产品开发更改

F03Z20046V-01

BOSCH	Impact analysis		Edition 2.0		
Confidential		影响分析			
		Corresponding DC No. / 对应的开发更改编号: RBCE-PDECR2026006			
		Date / 日期: 2026.03.25			
Step 3.1 Impact analysis / 影响分析

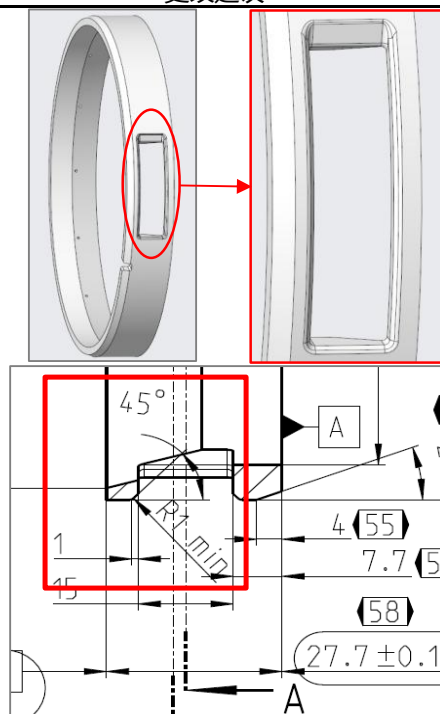
导油环回油口处未设计倒角，入机壳时导油环发生卡滞，压装不到位

回油口增加C角和圆角，避免压装发生卡滞

回油口增加: C角1x45°和圆角R1
